TO: Mercedes-Benz Dealer Principals, General Managers, Sales Managers, Service Managers, Parts Managers	FROM: Gregory Gunther, Department Manager, Vehicle Compliance and Analysis, Engineering Services
RE: Recall Campaign Launch Notification Repair Upfront Airbag Sensor Wiring Harness Routing MY20 GLS-Class (167 platform)	DATE: August 5, 2022

**Repair Upfront Airbag Sensor Wiring
Harness Routing**

SUBJECT: **Model GLS-Class (167 platform)**
Model Year 2020

Rework electrical wiring harness for front left acceleration sensor

Figure 1

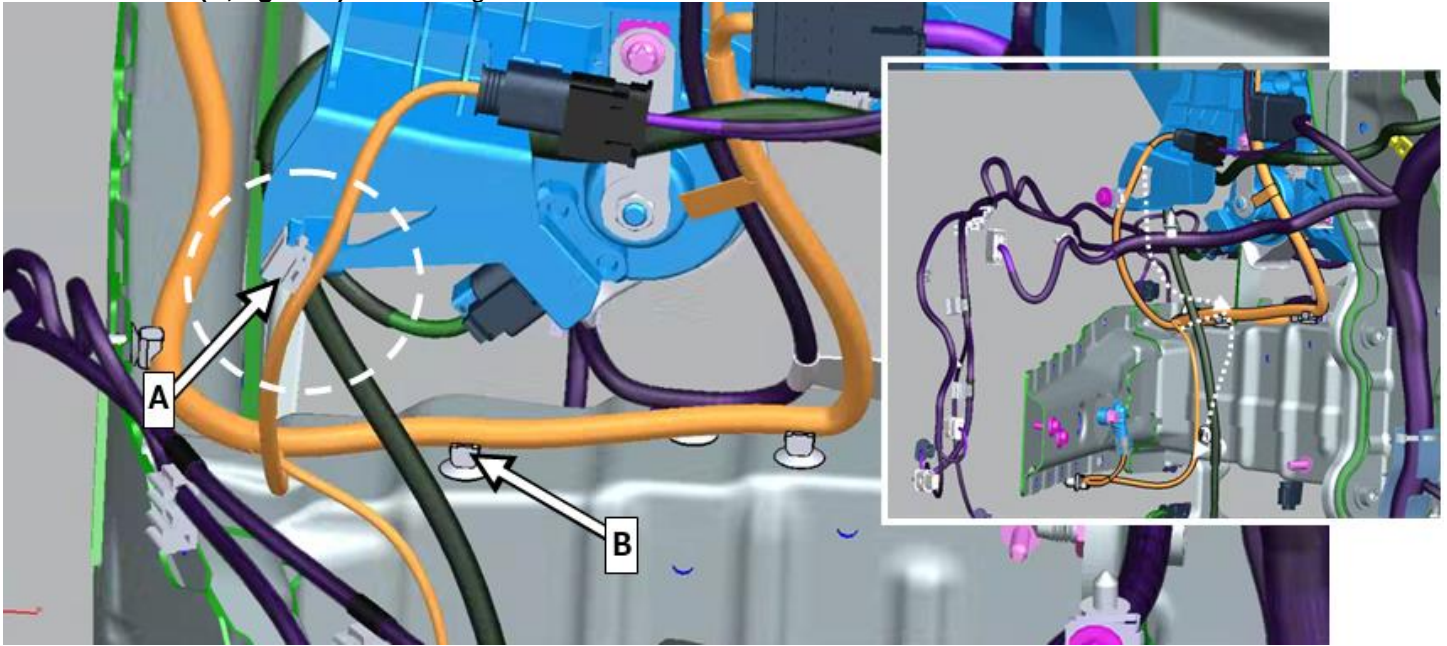
1. Remove front section from the front left fender liner.

Figure 2

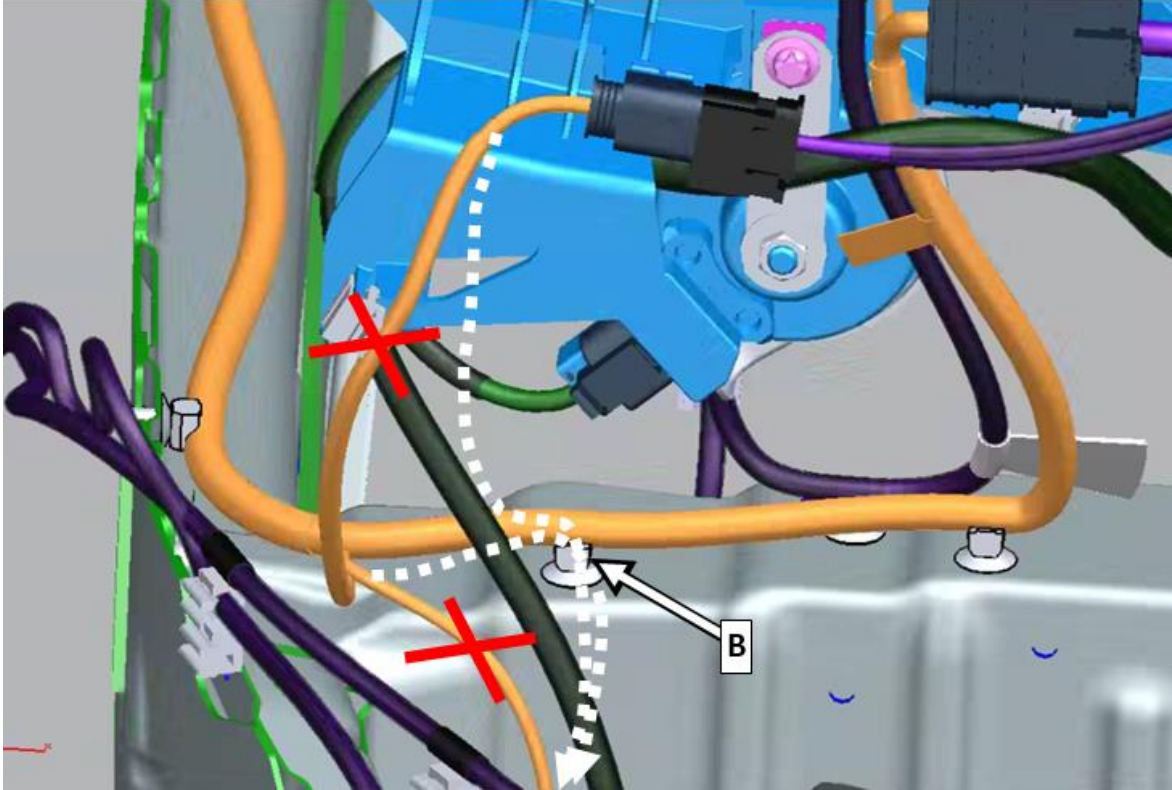
2. Remove bracket (A, figure 2) including cable tie from wiring harness and remove cable tie on bracket (B, figure 2) on upper left longitudinal member.

i Bracket (A, figure 2) will no longer be installed!
